26 April 2022

Subject: Addendum to the bushfire attack level assessment for Cadence Estate, stages 3a, 3b and 3c – 145 Binnies Road and 143-163 Daleys Road, Ripley, Queensland

Bushfire Attack Level Assessment
 145 Binnies Road &
 Project 143-163 Daleys Road, Ripley
 BAL Contours:
 Scenario a
 FIGURE 1

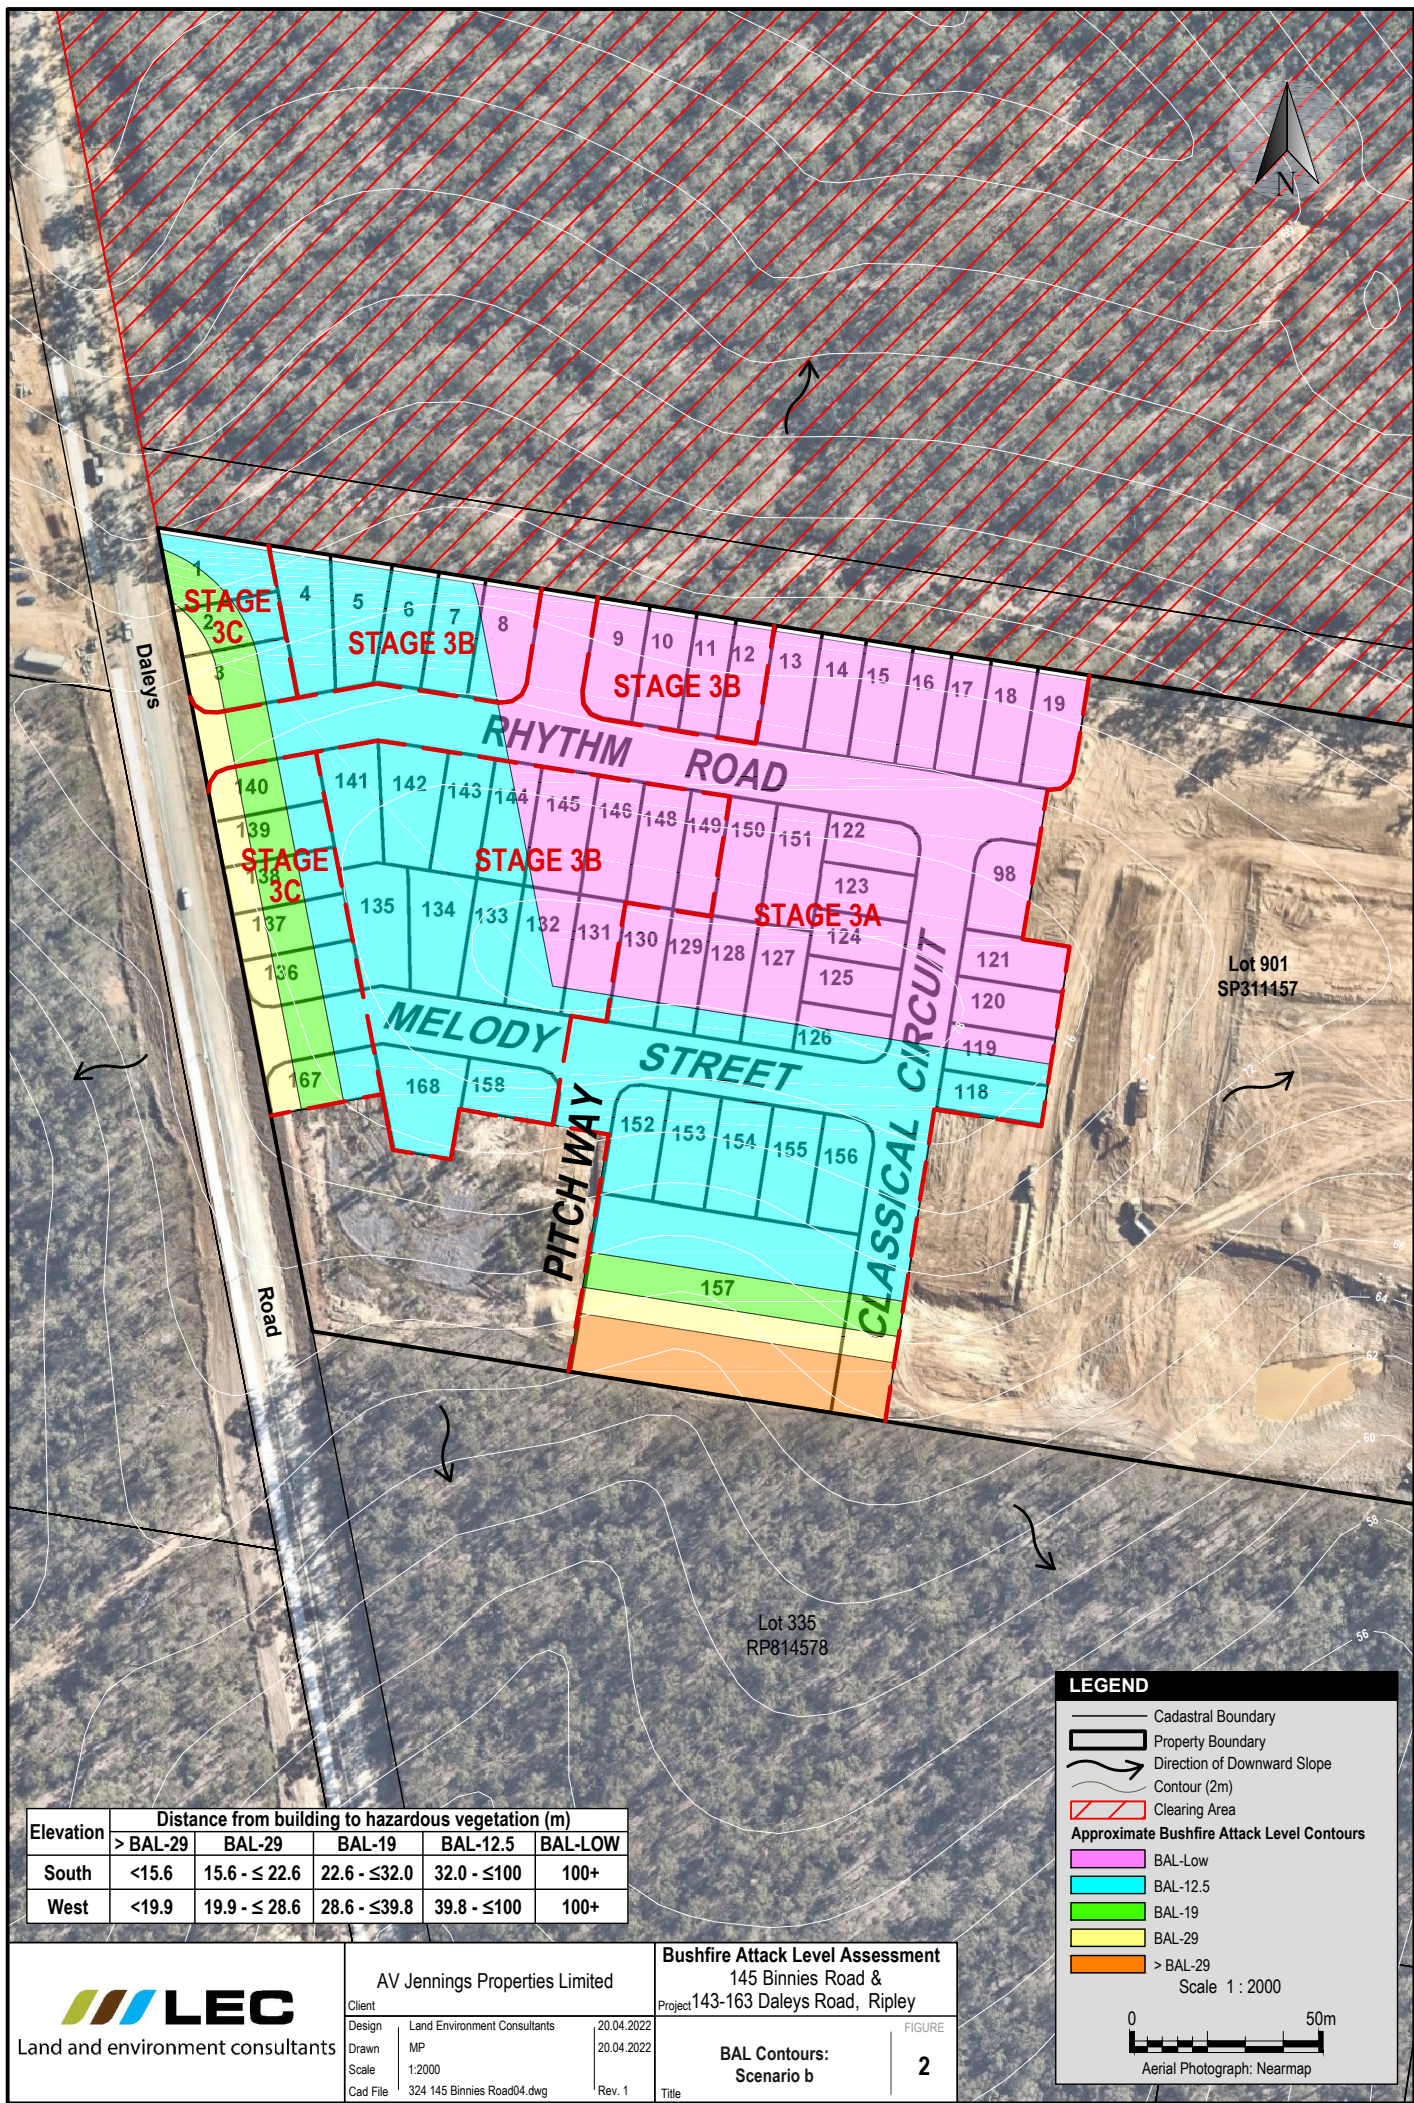
Since the BAL assessment for stages 3a, 3b and 3c was prepared in October 2021, vegetation has been cleared from land within 100 m of the northern boundary of stages 3a, 3b and 3c. This report documents the revised BAL assessment for lots within stages 3a, 3b and 3c based on the recently cleared vegetation along the northern boundary of stages 3a, 3b and 3c and two scenarios of vegetation retention/management adjoining the southern boundary of stages 3a, 3b and 3c. The two scenarios are as follows:

- a) a corridor of vegetation is cleared from the southern boundary of stages 3a, 3b and 3c as shown in Figure 1 (**Scenario a**); and
- b) vegetation is not cleared from the southern boundary of stages 3a, 3b and 3c as shown in Figure 2 (**Scenario b**).

Under clause 2.2.3.2 (a) of the *Australian Standard (AS 3959-2018) Construction of buildings in bushfire prone areas*, vegetation of any type that is more than 100 m from stages 3a, 3b and 3c shall be excluded from the BAL assessment. Therefore, bushfire attack on the northern boundary of stages 3a, 3b and 3c is no longer considered relevant to the BAL assessment for lots within stages 3a, 3b and 3c.

The revised BAL contours over stages 3a, 3b and 3c which considers vegetation cleared along the northern boundary of stages 3a, 3b and 3c and Scenario a and Scenario b of vegetation retention/management adjoining the southern boundary of stages 3a, 3b and 3c are shown in Figures 1-2. The revised BAL ratings of lots within stages 3a, 3b and 3c are summarised in Table 1. Lot 157 is a drainage reserve and a BAL rating is not relevant to this lot. Therefore, it is not listed in Table 1.

BAL-LOW	BAL-12.5	BAL-19	BAL-29	> BAL-29 (No building envelope)
Scenario a – refer to Figure 1				
9-19, 98, 118-131, 145-146 and 148-151	4-8, 132-135, 141-144, 152-156, 158 and 168	1	2-3, 136-140 and 167	-
Scenario b – refer to Figure 2				
9-19, 98, 120-125, 145-146 and 148-151	4-8, 118-119, 126-135, 141-144, 152-156, 158 and 168	1	2-3, 136-140 and 167	-
